**Project Name: \*** Widening of I-95 to Eight lanes from South of SR 1832 (Murphy Road – Exit 56) to South of SR 1811 (Bud Hawkins Road – Exit 70)

## I-5986A 4C Interagency Concurrence Point Meeting Minutes

Subject: Modification Request for Section 404 Individual Permit, Section 401 Water Quality Certification and Neuse Riparian Buffer Authorization for the Widening of I-95 to Eight lanes from South of SR 1832 (Murphy Road – Exit 56) to South of SR 1811 (Bud Hawkins Road – Exit 70), in Cumberland County, STIP No. I-5986A. Debit \$575 from WBS 47532.3.2.

PERMIT DRAWING SHEET 8 OF 163

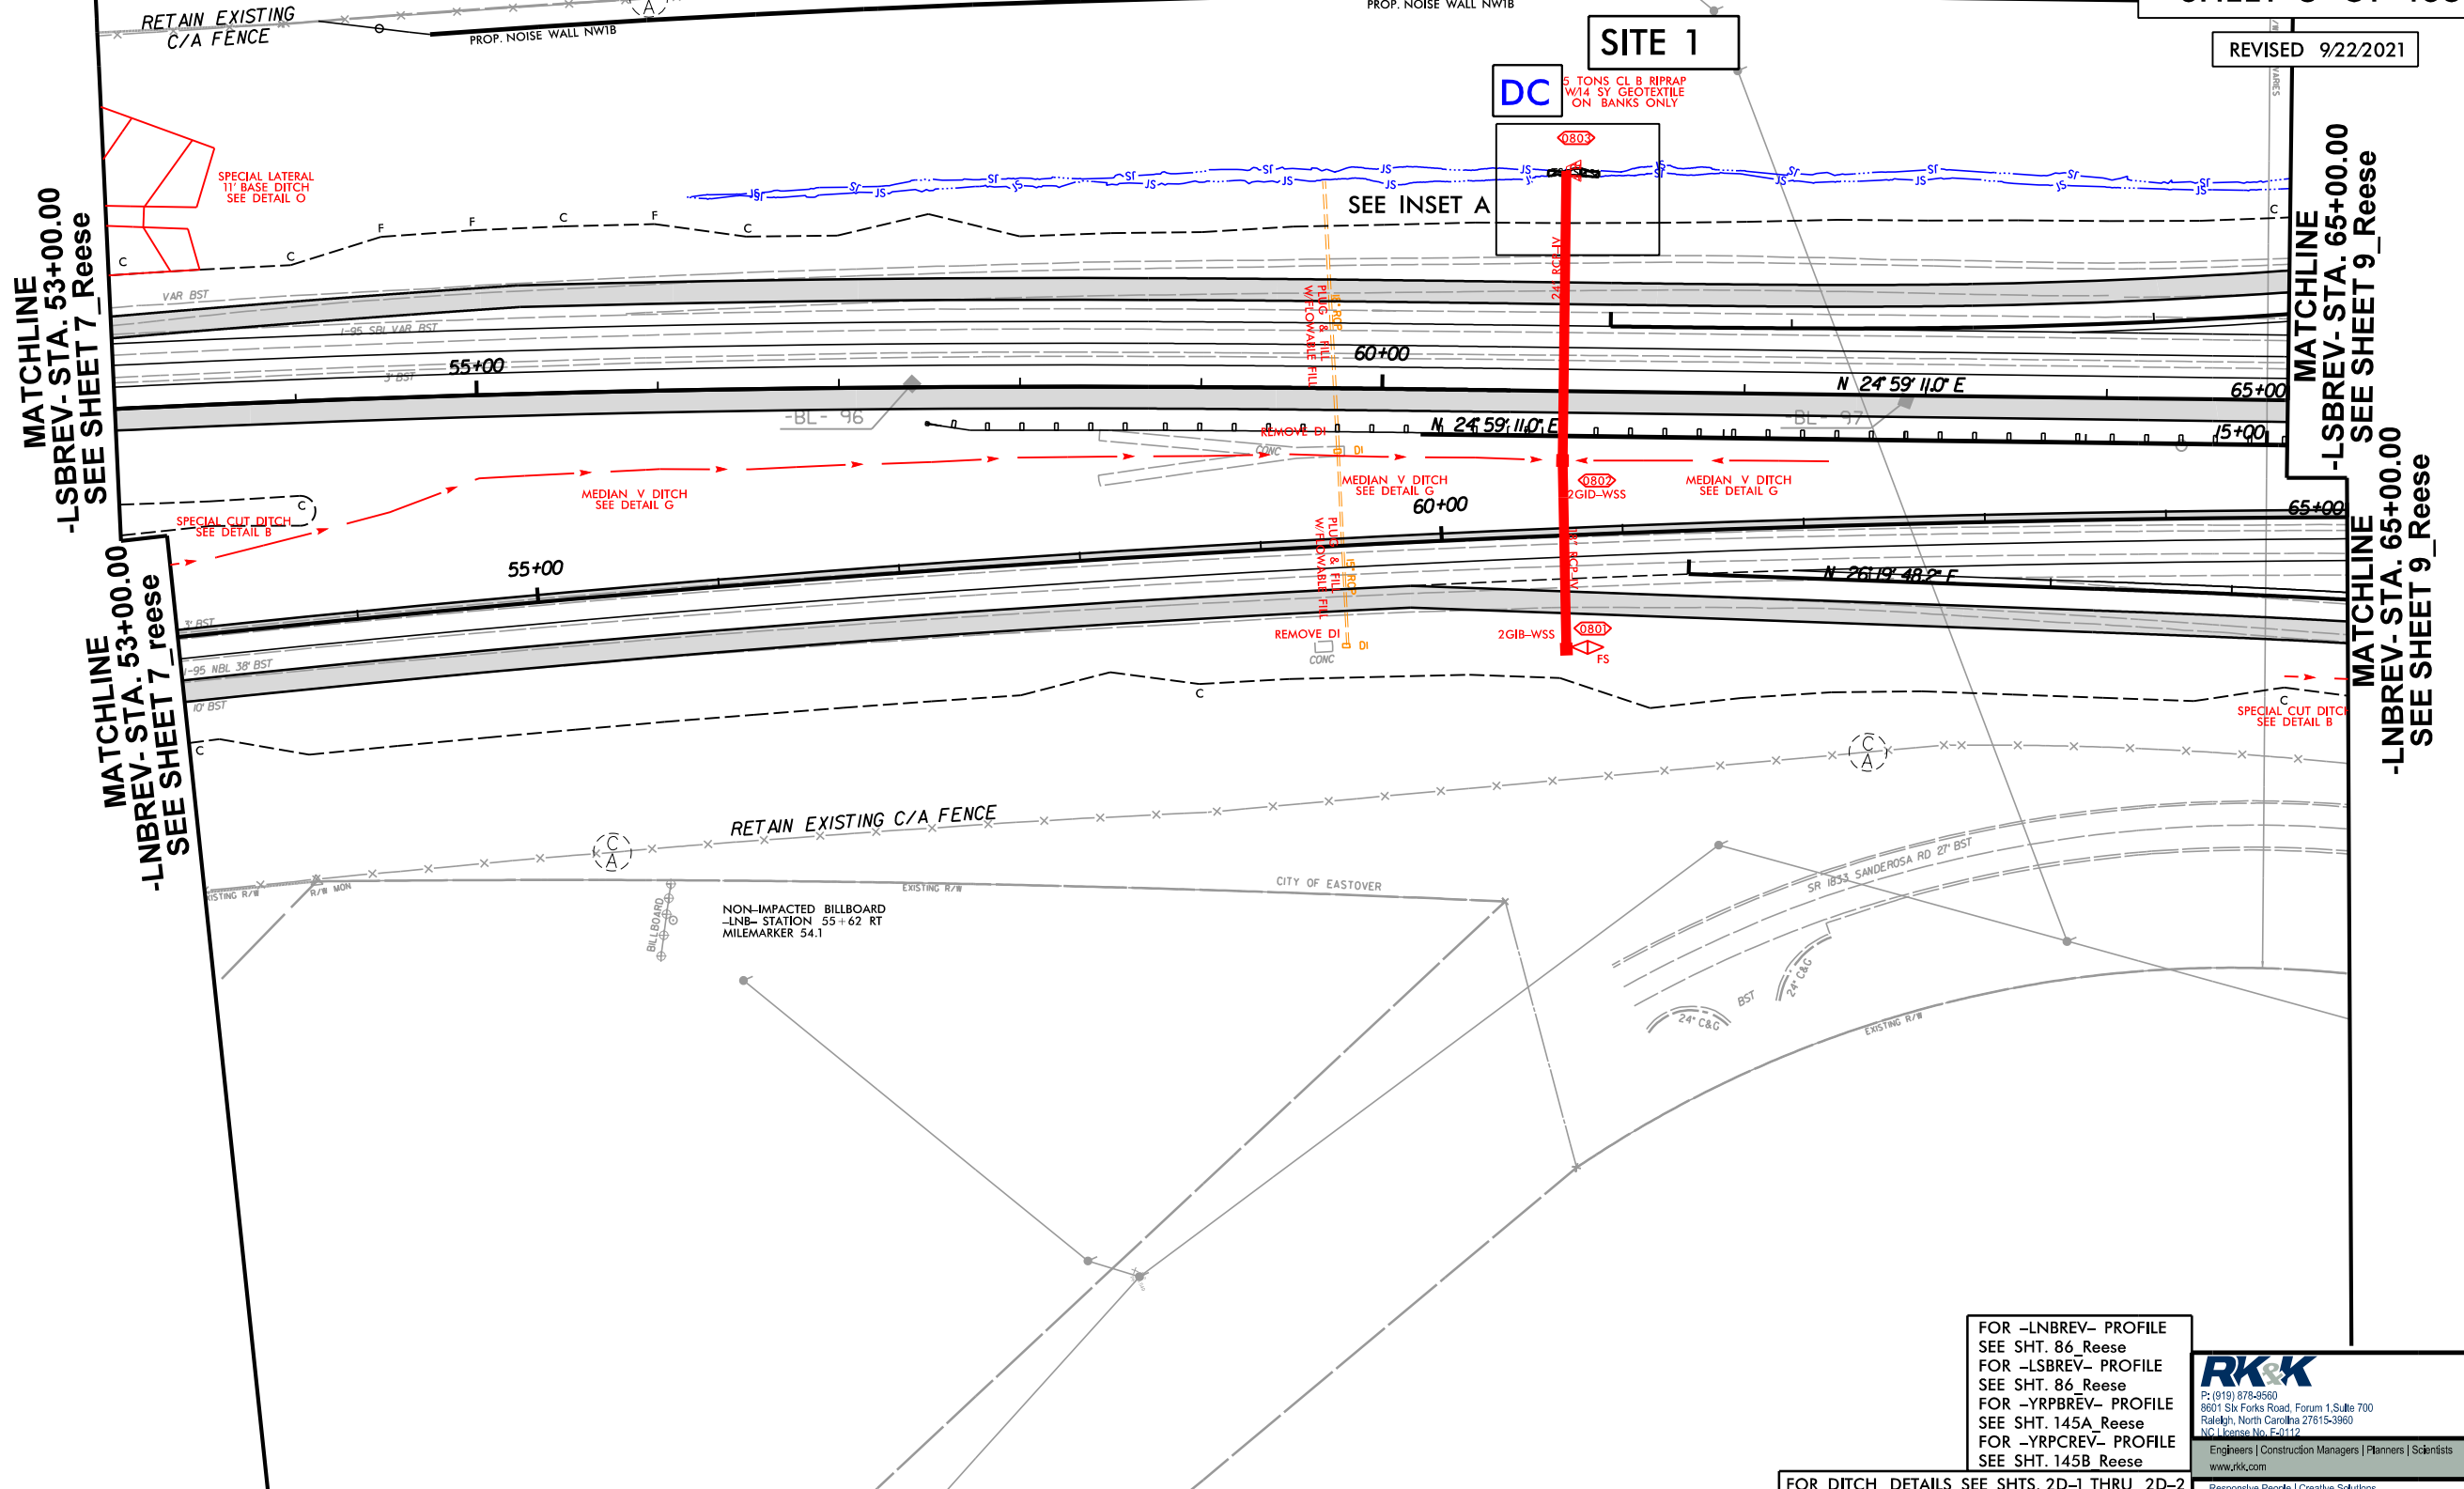
**Site 1.**

- 0.001 acre decrease in temporary surface water impacts

PERMIT DRAWING  
SHEET 12 OF 163  
REVISED 9/22/2021

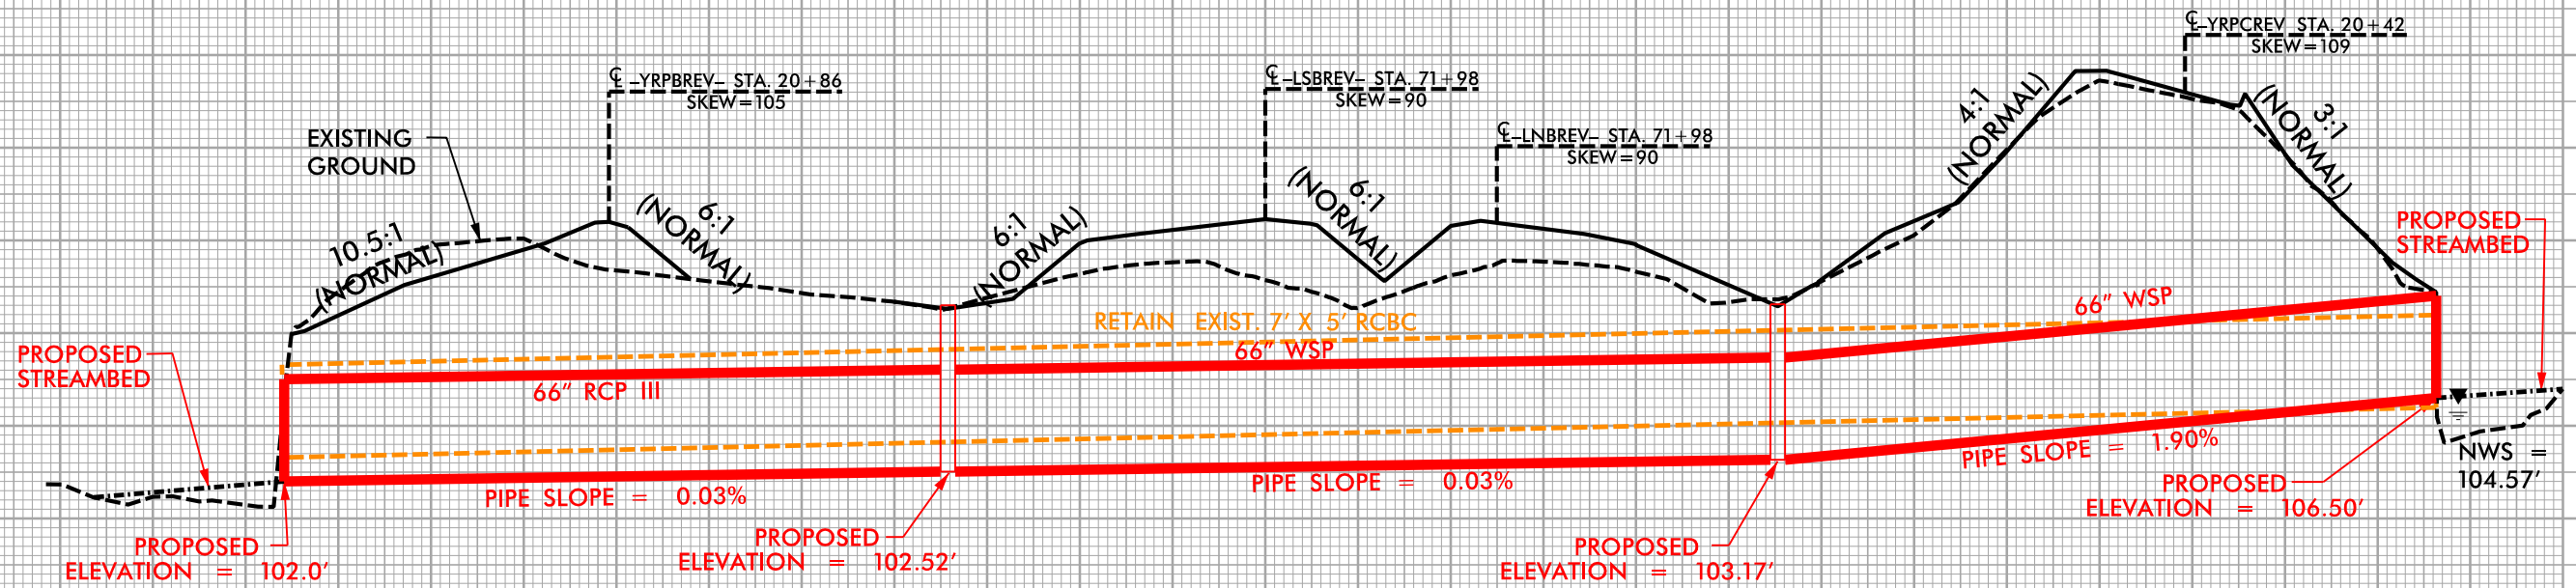
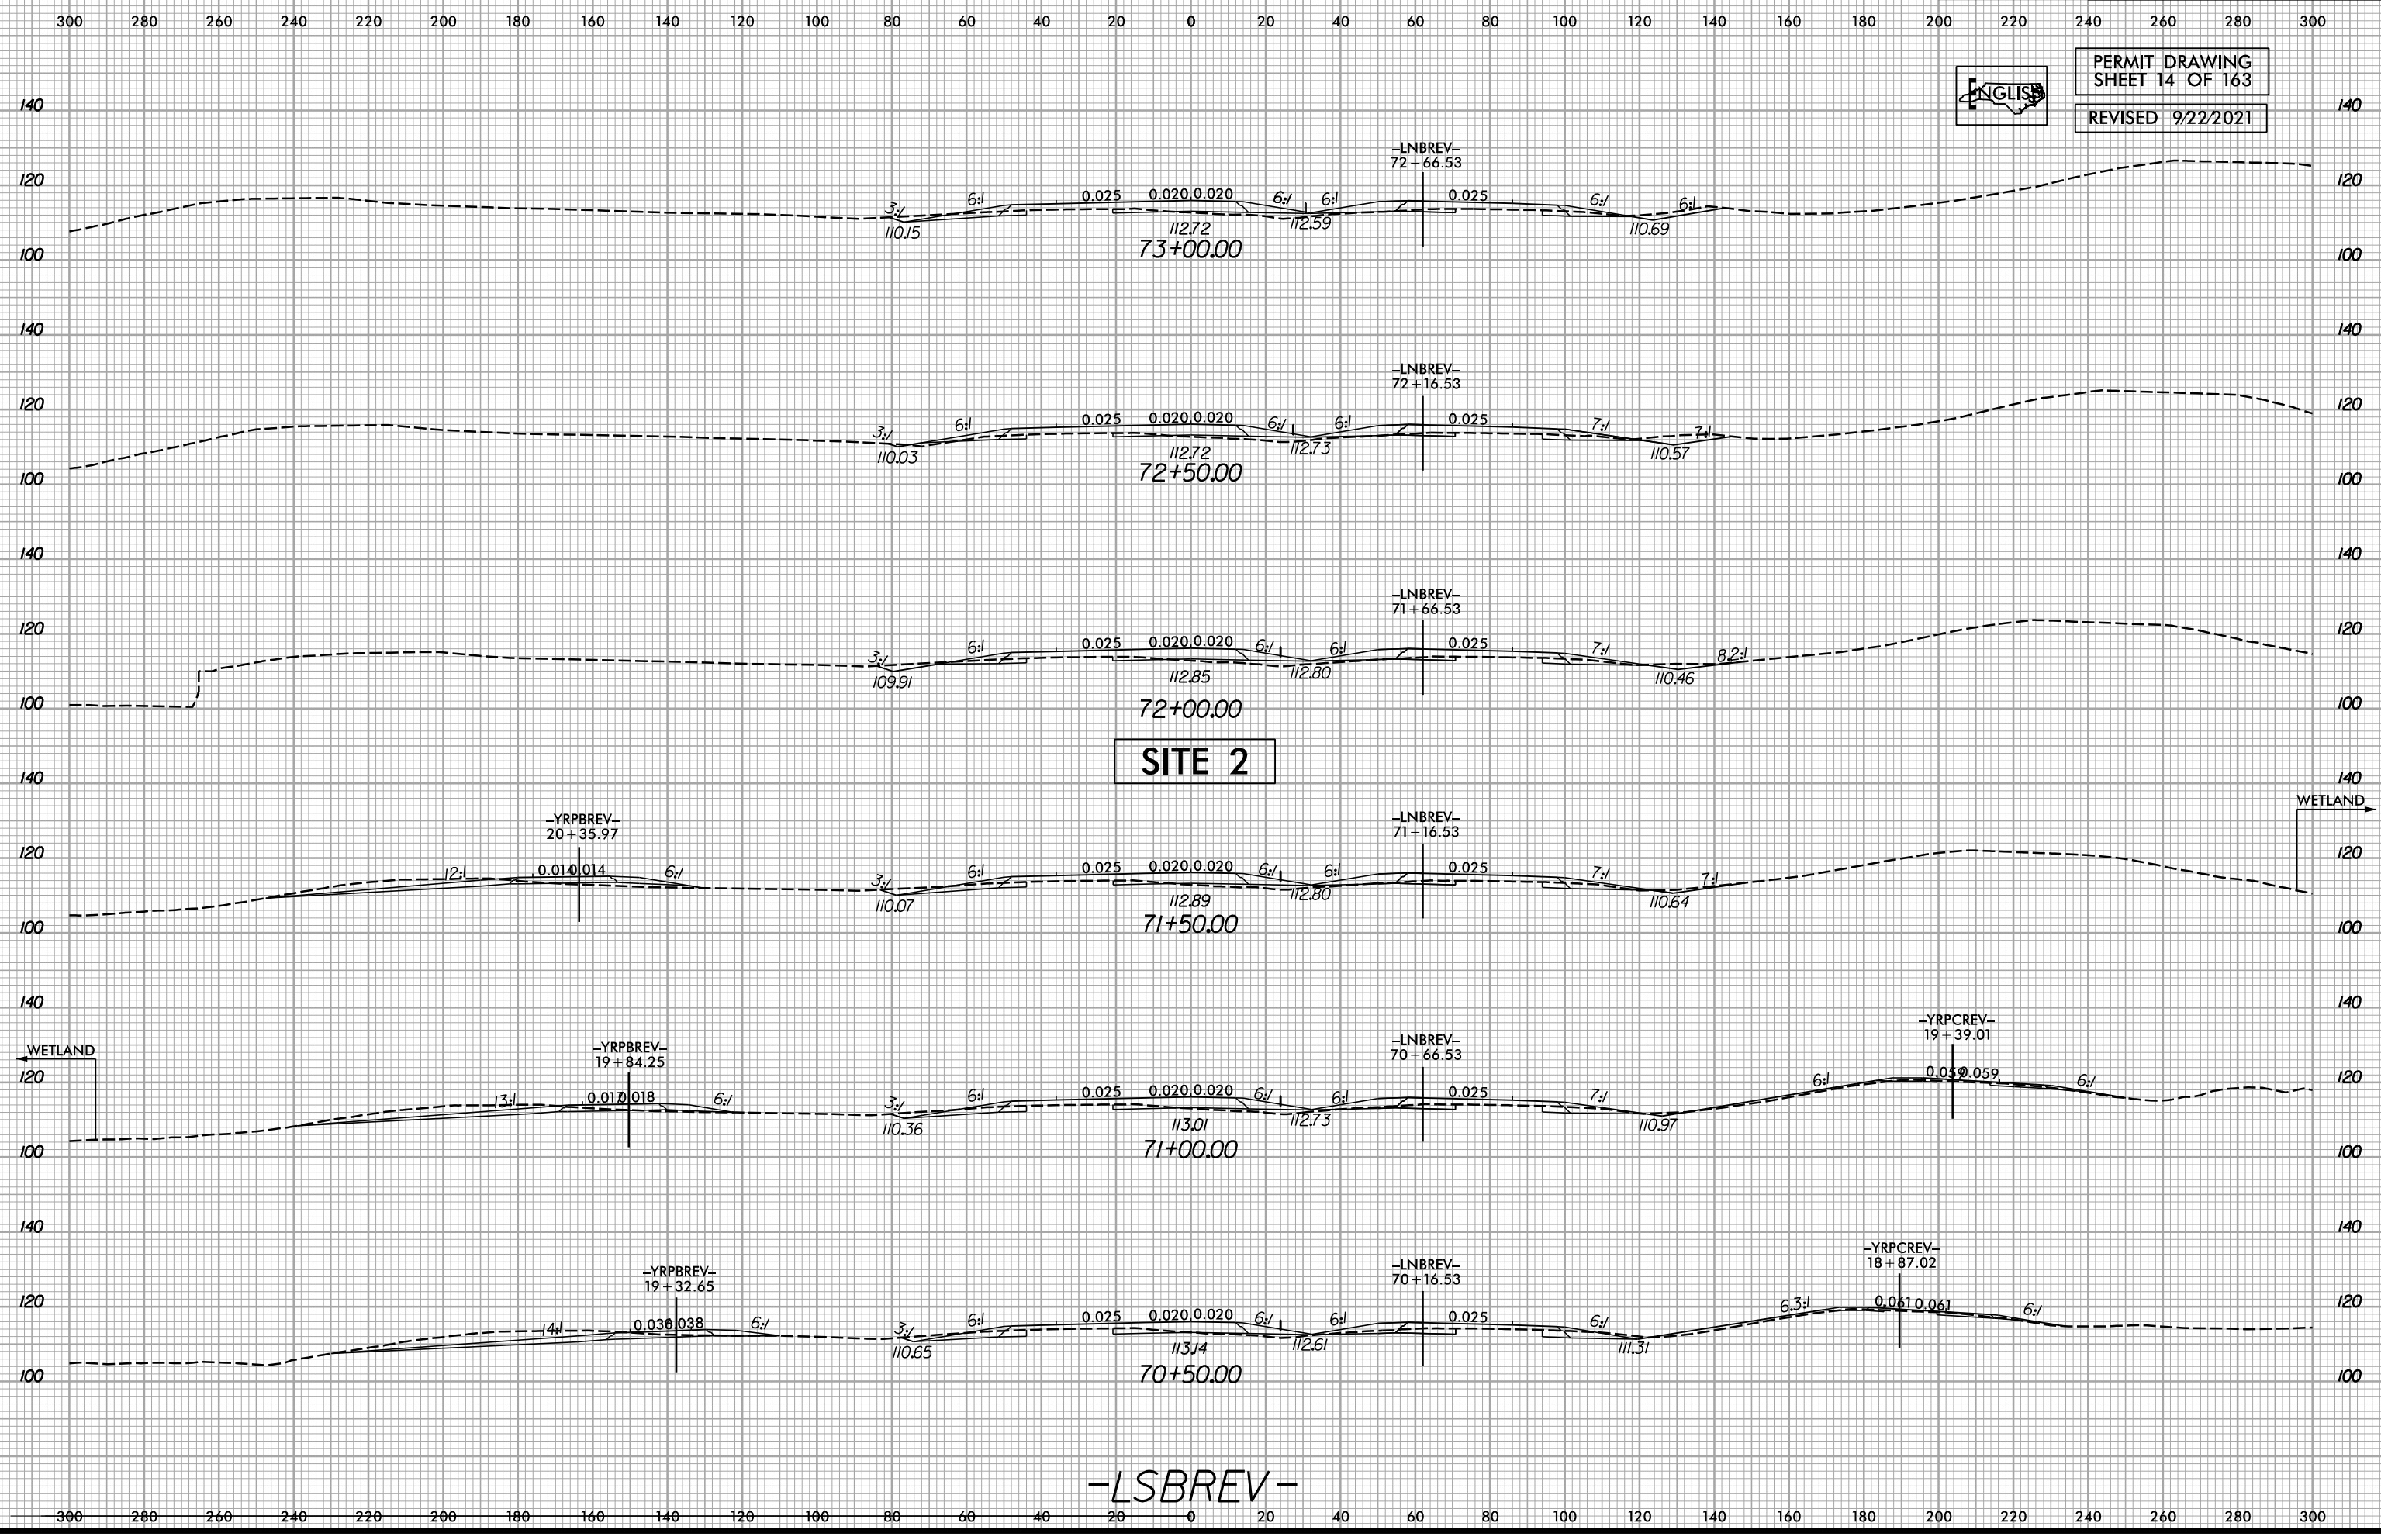
**Site 2.**

- 0.101 acre increase in permanent fill in wetlands.
- 0.001 acre decrease in temporary fill in wetlands
- 0.068 acre increase in mechanized clearing in wetlands
- 62 linear feet increase in permanent stream impacts
- 37 linear feet decrease in temporary stream impacts
